**Historic Preservation Commission
Agenda
June 15, 2020
6:30 pm**

maximum) as well as a new construction grant. Necessary preservation work identified in the Historic Structure Assessment includes siding repair, window replacement, foundation repair, floor and roof structure repair, front porch repair, wall structure repair, chimney work, and site grading for a total of \$151,099. Because this is a matching grant the request is for \$61,775. To be approved, work must fall into preservation, rehabilitation and restoration and staff stated that the work falls into those categories. Staff reviewed the wording of the new construction grant, Res. No. 17, Series 2019. The proposed addition meets the requirements including FAR below what is required, setback and height limitations. Staff recommends approval of Resolution 09, Series 2020, recommending approval of the following grants:

925 JEFFERSON AVENUE
HISTORIC RESIDENCE

925 Jefferson Avenue – East Elevation, current

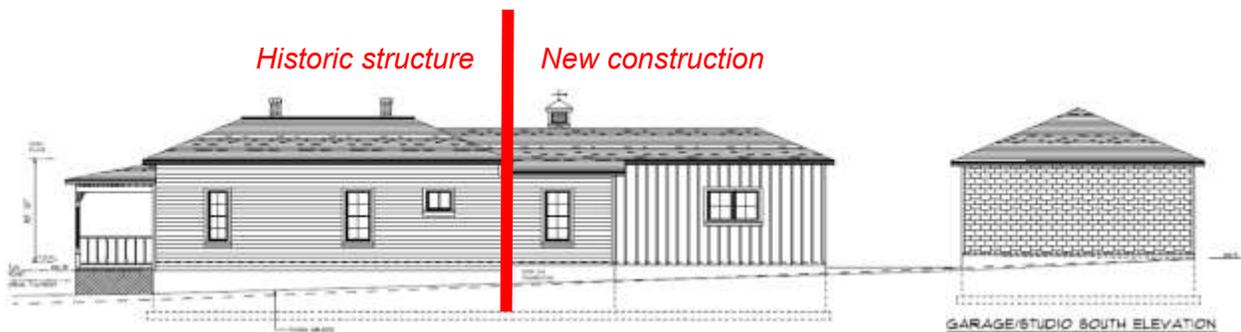
Current window size and location and door location will be retained.

Criteria and Standards	Meets Criteria?	Evaluation
1. <i>The effect upon the general historical and architectural character of the structure and property.</i>	Yes	The applicants have revised their plans and the current window and door placement will be retained. The window size will also be maintained. These changes will aid in maintaining the existing architectural character of the structure and property.

925 Jefferson Avenue – North Elevation, proposed

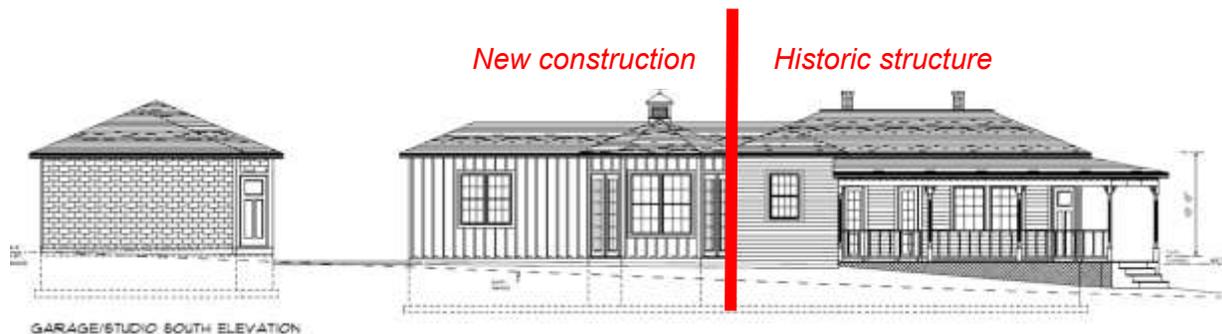
5. <i>The effects of the proposed work in creating, changing, destroying, or otherwise impacting the exterior architectural features of the structure upon which such work is done.</i>	Yes	The applicants have revised their plans and the current window and door placement will be retained. The window size will also be maintained. These changes will aid in maintaining the existing architectural features of the structure and property.
